Access Compliance Report

Public Rights-of-Way

(Curb Ramps)

Intersection ID: 24817	Main Street: ASHRIDGE_DR	Cross Street: TRUSCOTT_RD	Location: NE
ADA ID: 1EE3FBD0729B	Ramp Type: PerpDiag	Initial Pass/Fail: Fail	Overall Compliance: No
Severity Score: 8.75			
Codes/Mitigation Info/Possible Solution		Field Measurements/Component Compliance

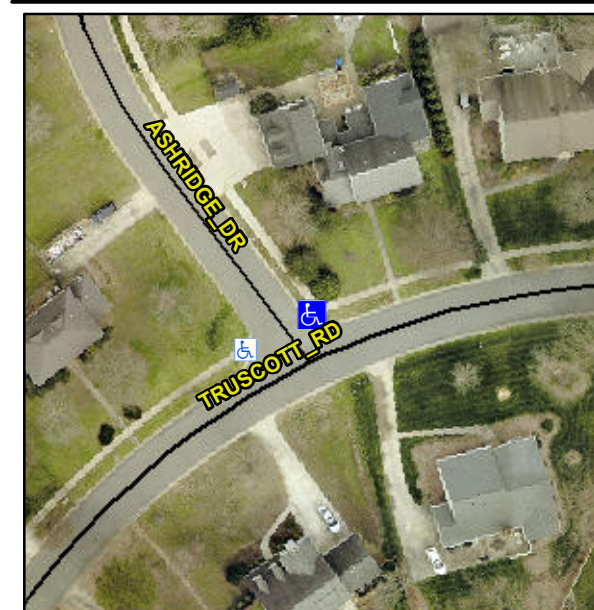
Not Found, R304.5.1

Compliance	Description	Data	Compliance	Description	Data
N/A	Ramp Length (in)	48.0	Yes	Ramp Slope (%)	6.6
No	Ramp Width (in)	46.0	Yes	Ramp XSlope (%)	1.1
N/A	Flare Type LT	N/A	N/A	Flare Type RT	N/A
N/A	Flare Slope LT (%)	N/A	N/A	Flare Slope RT (%)	N/A
N/A	Flare Traversable LT?	N/A	N/A	Flare Traversable RT?	N/A
N/A	Landing Length (in)	N/A	N/A	DWS Provided?	N/A
N/A	Landing Width (in)	N/A	N/A	DWS Contrast?	N/A
N/A	Landing Slope (%)	N/A	N/A	DWS Length (in)	N/A
N/A	Landing X Slope (%)	N/A	N/A	DWS Full Width?	N/A
N/A	Landing Curb? (Y/N)	N/A	N/A	DWS Offset (in)	N/A
N/A	Shared Landing?	N/A			
N/A	Gutter Ponding?	N/A	N/A	Gutter Slope (%)	N/A
N/A	Gutter Lip Ht (in)	N/A	N/A	Gutter X Slope (%)	N/A
N/A	Painted X Walk1?	No	N/A	Painted X Walk2?	No
	X Walk 1 Direction	To W		X Walk 2 Direction	To S
N/A	X Walk 1 Width (in)	N/A	N/A	X Walk 2 Width (in)	N/A
	X Walk 1 Slope (%)	0.6		X Walk 2 Slope (%)	1.8
	X Walk 1 X Slope (%)	1.9		X Walk 2 X Slope (%)	0.2

Remove & Replace Curb Ramp With Two New Directional Ramps or Equivalent.
